## Haverhill Area Working Party 8 September 2011

| <b>Report Title:</b> | HAVERHILL HIGH STREET IMPROVEMENTS<br>PROGRESS REPORT |

**PROJECT**  
 High Street Improvements  
 Haverhill

**DESIGN**  
 Preliminary Design  
 Southern Exit

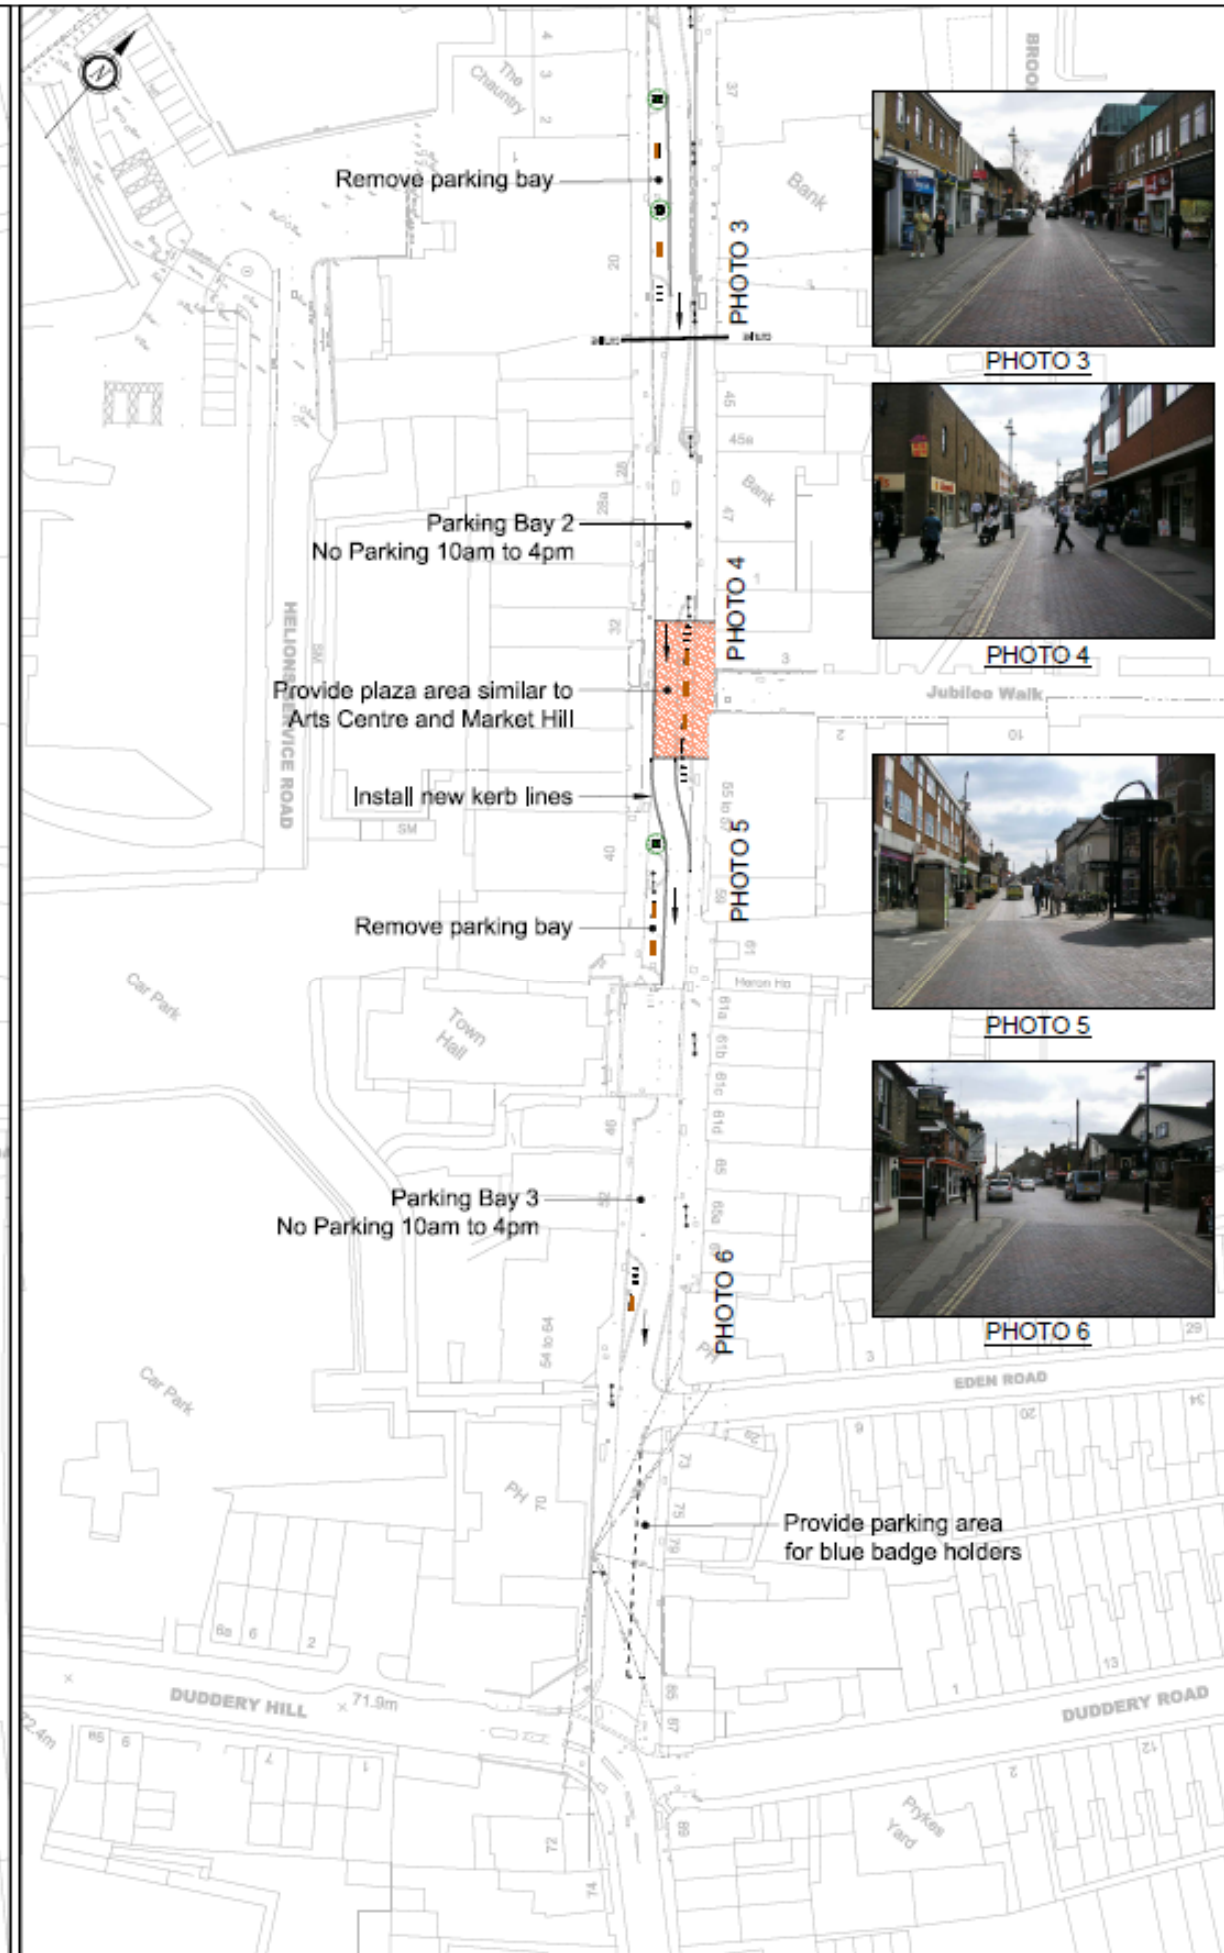
11. There are two options for addressing the removal of Quakers Lane as an access, both options would prohibit parking in the Market Hill section, with loading only permitted from marked bays. The first option would be to remove access to the whole of the High St during the restricted hours. This would remove all vehicles from the area and enforcement would be straight forward. However, access through the High St would be retained for funerals and weddings. This option is likely to result in objections to the order and therefore a public inquiry would be needed. However, pedestrianisation of the area is the ideal outcome for many.

- The potential for vehicles to park within the High St
  13. The proposed changes to the section of the High Street between Quakers Lane and Eden Rd will include a reduction in the number of parking bays within the High St, to encourage parking in the rear car parks. There would also be no parking permitted during 10am to 4pm, Monday to Thursday, and 6am to 6pm on the Friday and Saturday and outside of these hours parking only by blue badge holders and for loading. Works would be carried out to extend the feel of the Market Hill shared space scheme to include;

- Removal of the yellow lines, with the implementation of a restricted zone.
    - Placement of street furniture to reduce possible parking on the footway.

- Removal of two sections of parking and paving them as footway. The remaining three parking bays would be for use by blue badge holders and loading only, for the periods outside of the restricted access. This will significantly reduce the need of vehicles to use the road. To make this acceptable it may be necessary to introduce a short period of free parking, 30mins say, to the rear car parks.

- Treatment to the area next to Jubilee Walk to be similar to the squares provided in the Market Hill section and outside the Arts Centre.
  - Provision of blue badge holder parking for access off Eden Road to provide improved access to the High St, this could be accessed from Eden Rd not via the High St during the restricted times.

14. It is also recommended that an access restriction is added to the Swan Lane entrance, opposite the police station. This would significantly reduce the volume of traffic using the route and join up the Queen St section to the main High Street and also reduce the number of vehicles that are in the area to be able to abuse the access restriction down the High St. This would require access to the facilities in Camps Rd from Crowland Rd, requiring a section of one way in the opposite direction to that currently being considered. The remaining section of Swan St would also need to be made two way. This proposal is controversial but it would be a real benefit to the scheme. Currently this proposal is supported by the Town Council, the police and the County Councillors, but not the Chamber of Commerce.

15. It is proposed that to improve blue badge holder parking to the Market Hill area, a good quality access from the rear car park via the entrance next to the post office, will be provided with appropriate reallocation of blue badge holder parking bays.

A plan showing the new proposals is attached.
